BE IT REMEMBERED on the 30th day of April 2012, there was conducted a Special Meeting of the Cameron County Regional Mobility Authority, at the Joe G. Rivera and Aurora de la Garza County Annex thereof, in San Benito, Texas, for the purpose of transacting any and all business that may lawfully be brought before the same.

B. Consideration and Approval of Change Orders #2, #12, #15 and #16 for the SH 550 Project

**3-B CONSIDERATION AND ACKNOWLEDGEMENT OF CHANGE
ORDERS #2, #12, #15 AND #16 FOR THE SH 550 PROJECT**

ROADWAY ILLUMINATION ASSEMBLY SHEET SUMMARY

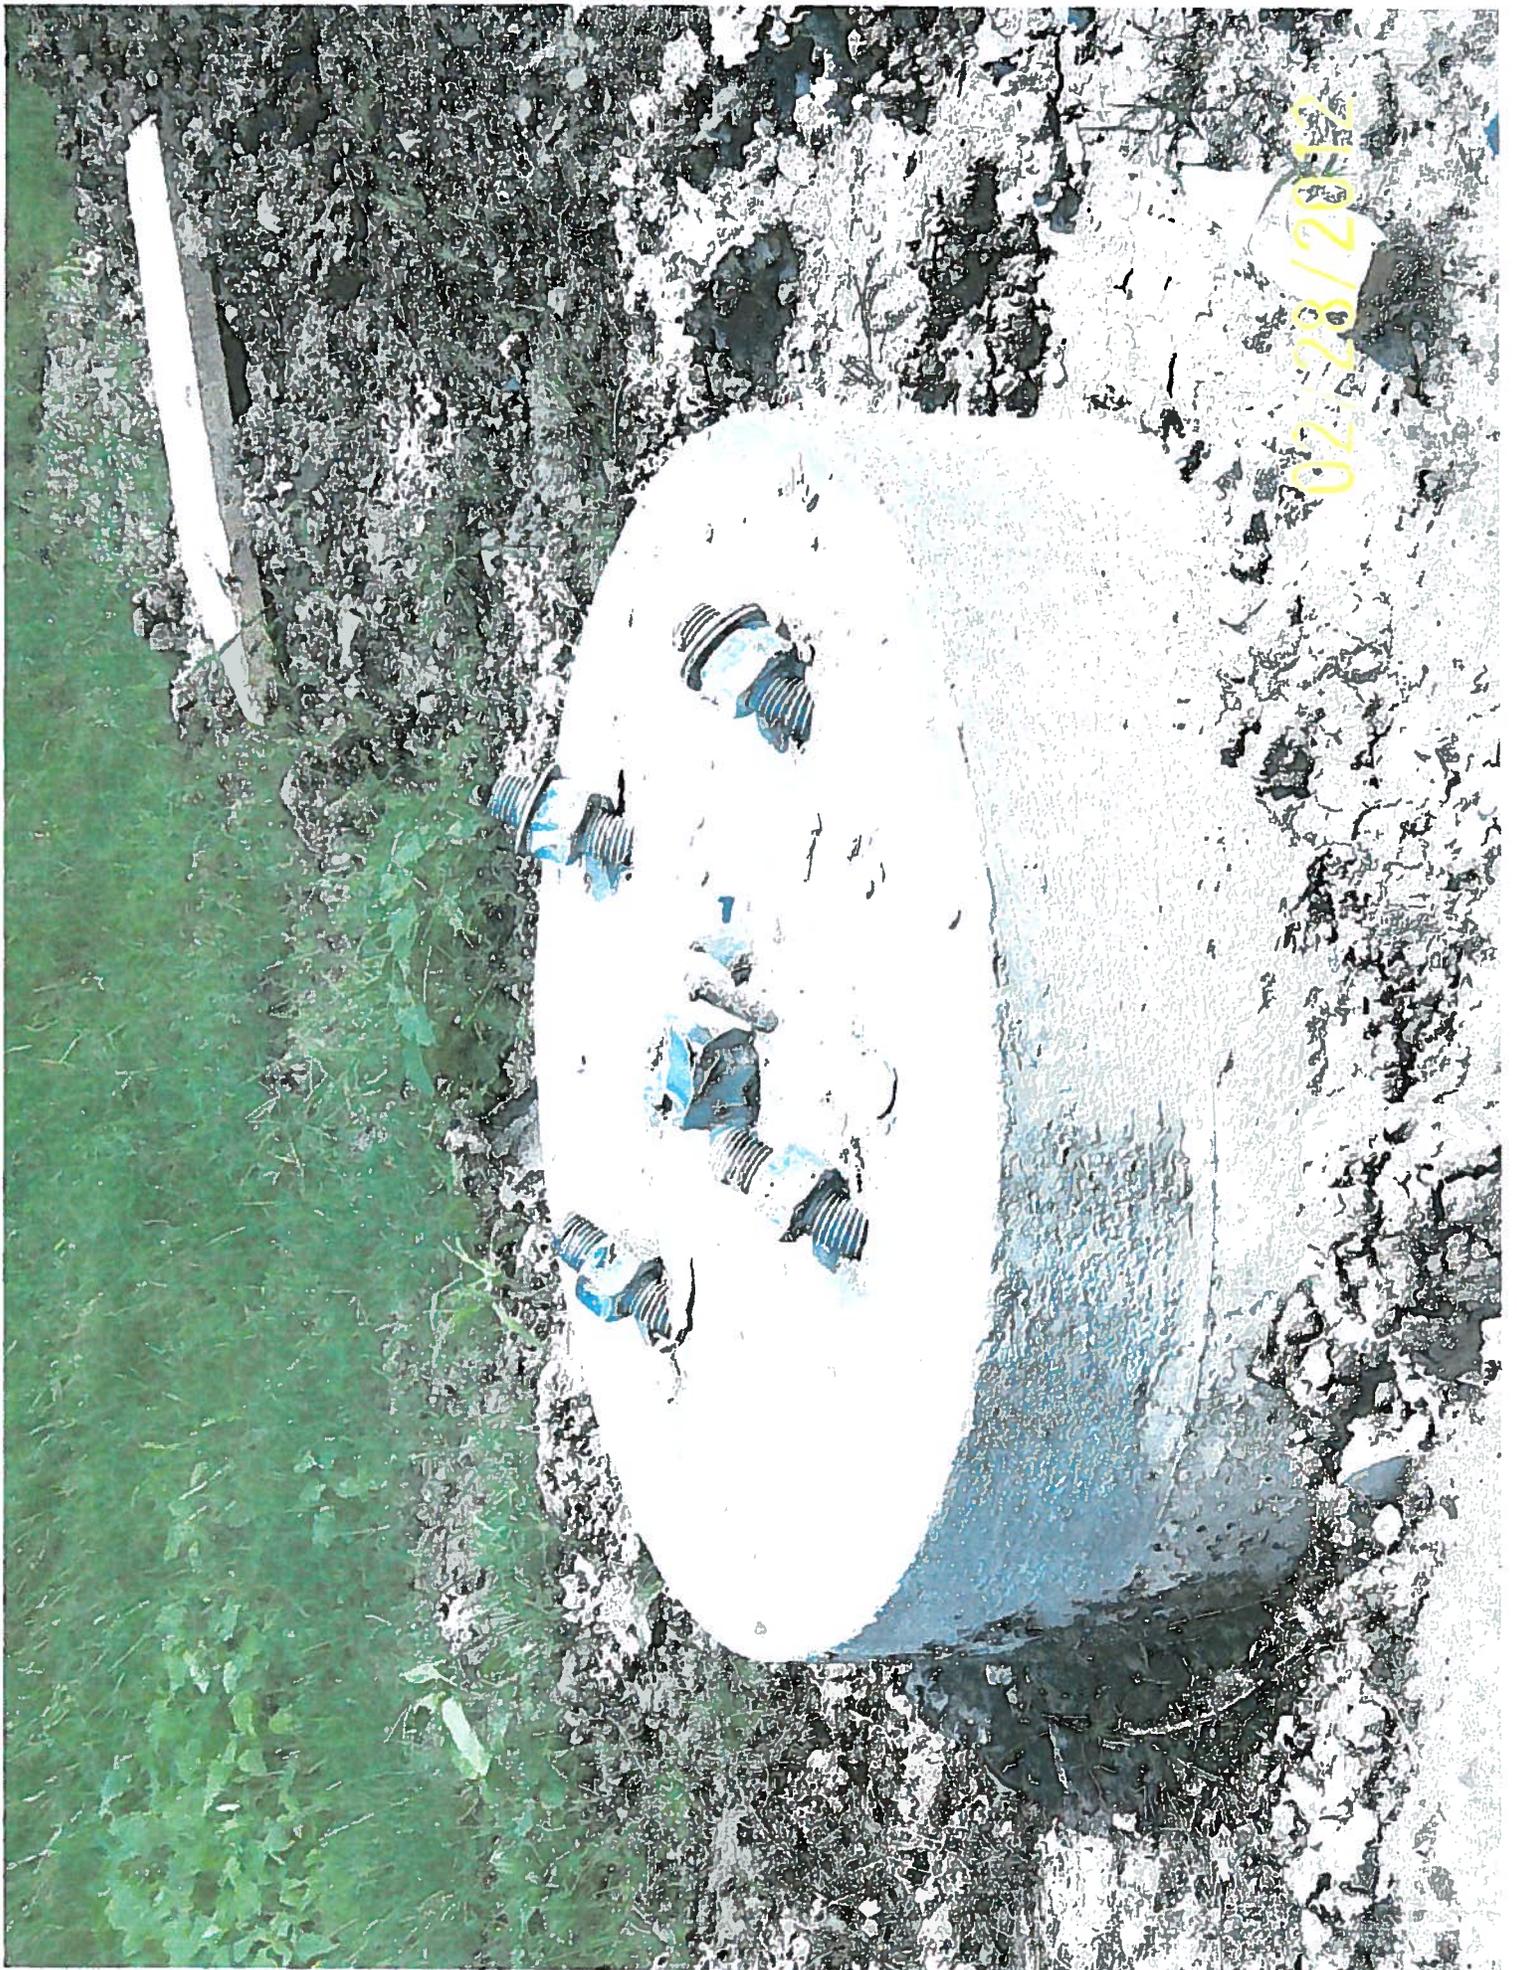
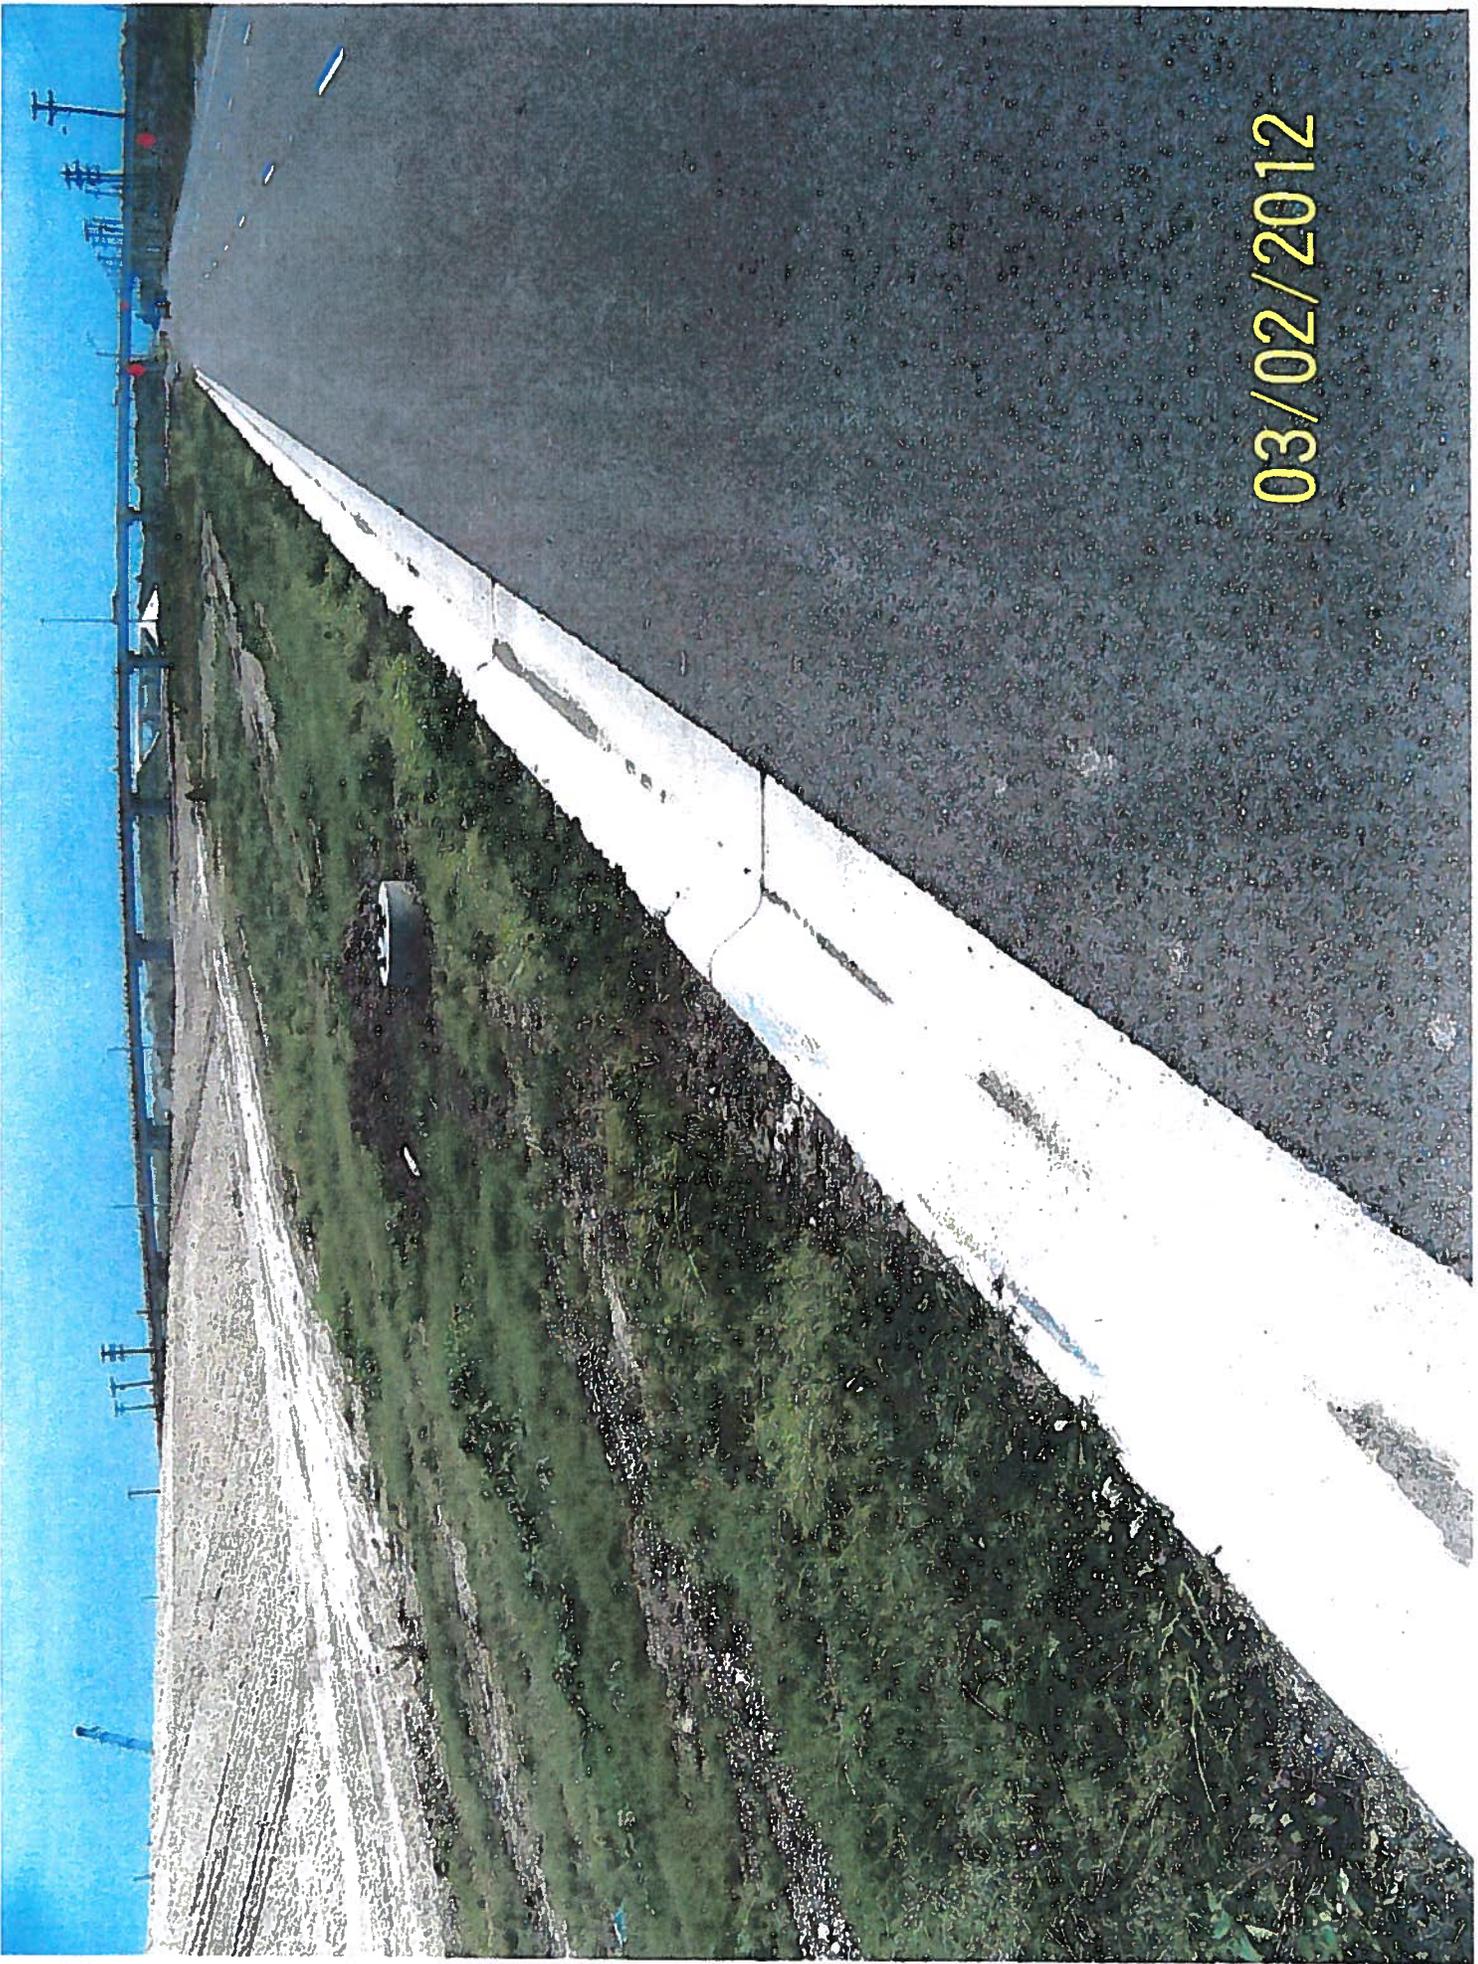
Change Order# 16 introduces an additional 30" drill shaft with anchor bolts to replace a proposed damaged roadway illumination assembly drill shaft.

Plans call for contractor to install a proposed 30" drill shaft for a proposed roadway illumination assembly (C-5) on existing SBFR at STA. 354+15 (L.T). Contractor installed 30" drill shaft and anchor bolts as per plans. TxDOT inspector discovered damage to anchor bolts caused by the general traffic during contractor non-working hours several days after drill shaft was poured. Therefore, TxDOT instructed contractor to re-drill shaft with new anchor bolts 5 feet up-station from original location. Contractor will remove damaged drill shaft 18" below natural ground elevation.
